**MCPB**  
Item No.  
Date: 06.17.2021

## 6940 Seven Locks Road (Franklin Property), Administrative Subdivision 620210070

### Administrative Subdivision Plan No. 620210070

Figure 3: Proposed Administrative Subdivision Lot Configuration

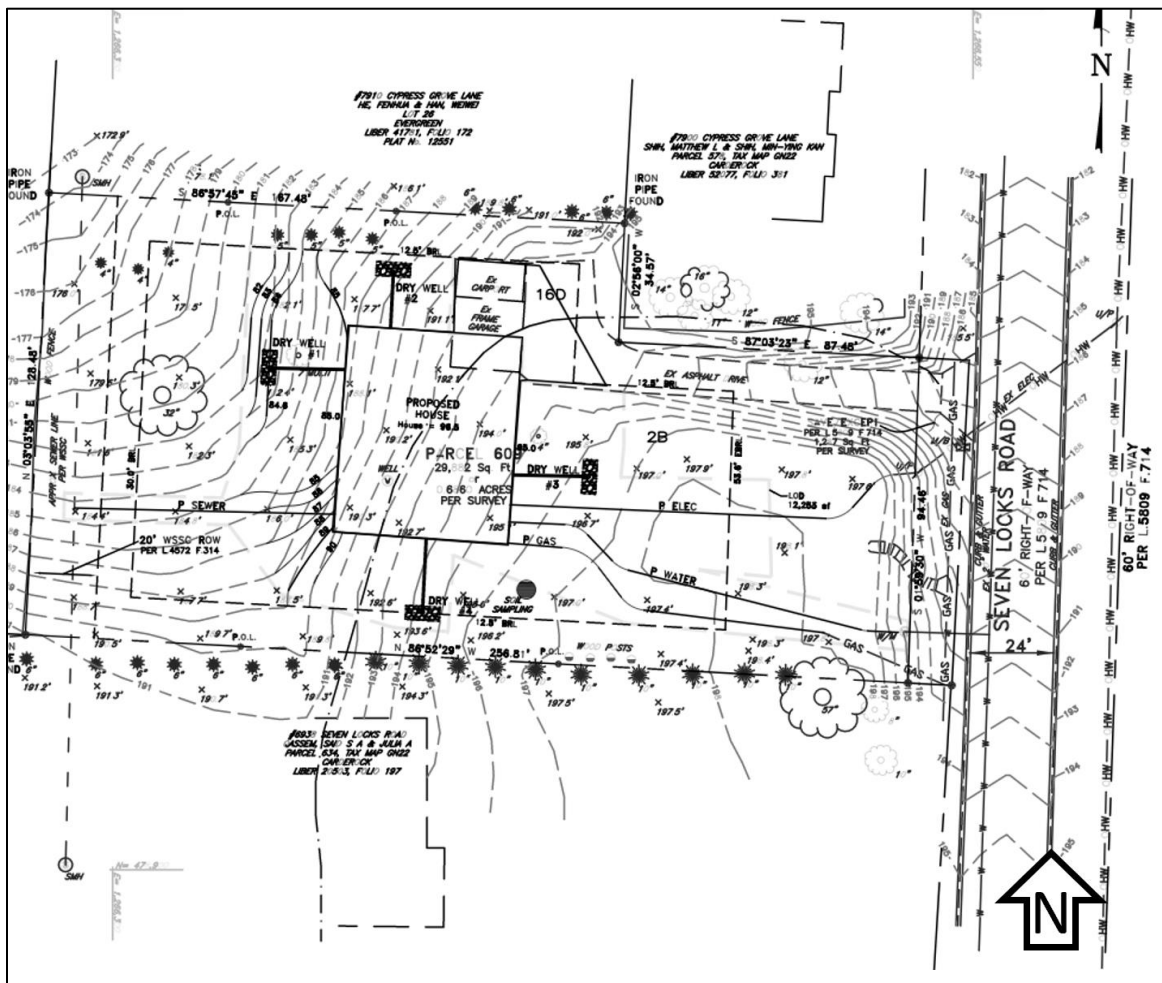
Given that the site has steep slope/highly erodible soil and is in the Palisades Staff recommends a 90' rear BRL to protect the soils/slopes. As conditioned, a 90' rear BRL would help protect the steepest part of the slopes and protect most of the erodible soil area.

8. Prior to Certification of the Administrative Subdivision Plan, the Applicant must revise the Plan to include a cross-section of Seven Locks Road showing the master-planned right-of way width, the sidewalks and master-planned bikeable shoulders on the west side of Seven Locks Road along the Property's frontage.

11. The record plat must reflect a 90' rear building restriction line (BRL) as shown on the Certified Administrative Subdivision Plan.
12. Prior to Certification of the Administrative Subdivision Plan, the Applicant must submit and receive M-NCPPC Staff approval of a new Forest Conservation Exemption Request or a Preliminary/Final Forest conservation as applicable.
